SSD-63475709 Tumbi Umbi Retirement Living Project

Please find enclosed a response to the submissions received on the Tumbi Umbi Retirement Living Project from Central Coast Council (dated 22 August 2025) and NSW Department of Climate Change, Energy, the Environment and Water (DCCEEW) (dated 18/08/2025).

Submission	Response
NSW Department of Climate Change, Energy, the Environment and Water (DCCEEW) – 18/08/2025.	
ACTIVITIES ON WATERFRONT LAND Works within waterfront land be designed and constructed in accordance with the Guidelines for Controlled Activities on Waterfront Land. The design and construction of works within waterfront land of the mapped 2nd Strahler order watercourse must consider the Guidelines for Controlled Activities on Waterfront land.	As per the response provided to DCCEEW’s submission dated 11 December 2024, Section 3.6 of the project BDAR provides a watercourse assessment. In summary: + Assessment of historical imagery shows that the existing drainage swale to the west of the development site was constructed in the early 2000s in tandem with the constructed wetland (northwest of the development site). Historical imagery from 1965 to 2005 only indicates man-ma

Figure 1. 1% AEP flood level difference

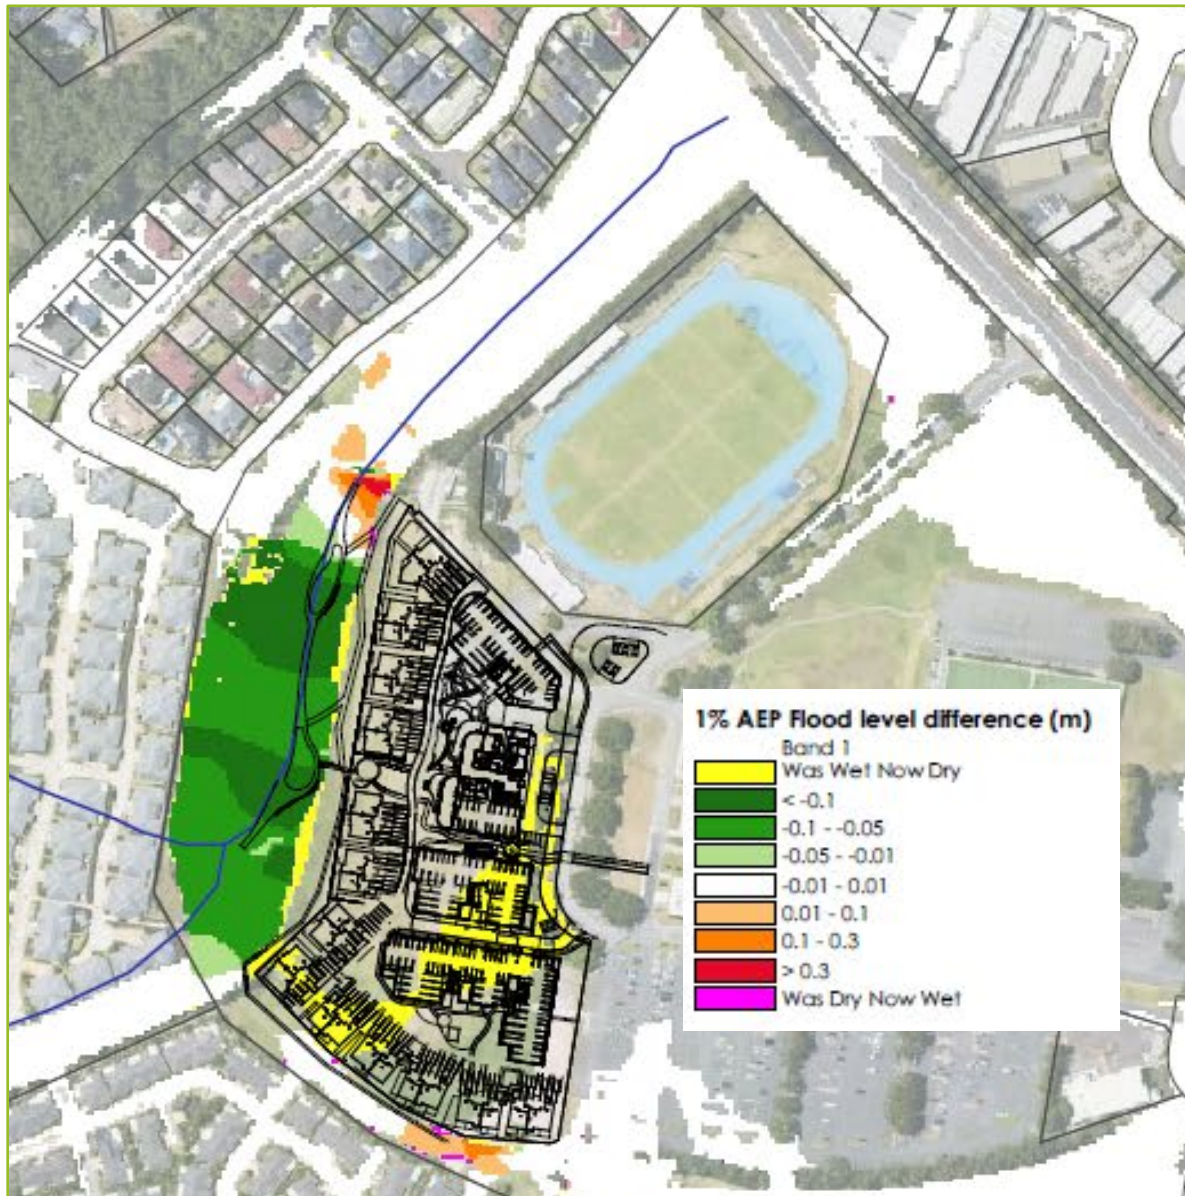
FLOODPLAIN DEVELOPMENT The Flood Impact Assessment shows an isolated increase in flood level in the existing watercourse presumably because that is where flow is being directed. The increase is shown to be greater than 300mm during the 1%AEP event. Floodplain Management acknowledge that this increase does not affect any neighbouring properties however cannot be sure that it is not	The existing drainage channel adjacent to the site is concrete lined and the downstream wetland was constructed in the late 1990s. The constructed wetland was planted with macrophytes that are true aquatic species and capable of surviving various inundation levels. The 1% AEP flood level differences are shown in Figure 1 and the wetland shown in photo plates 1 & 2.

Submission	Response
going to have a detrimental impact on the existing natural habitats within the watercourse. Floodplain Management recommend that an ecologist provide comment about the significance (if any) of this impact. If there is not predicted to be any ecological impact resulting from this development Floodplain Management have no further issues.	Native vegetation growing on the batters of the existing channel also comprise terrestrial and semi-aquatic plant species (e.g., sedges, rushes, aquatic grasses and paperbarks); and that found in Forested Wetland vegetation formation and Coastal Forested Floodplain class. These wetland communities have evolved under periodic flooding conditions that would last longer than that of a post-development 1% AEP event. Temporary, infrequent increases in water levels of >300mm are considered highly unlikely to impact on wetland flora or fauna at this locality, or further downstream of the site.
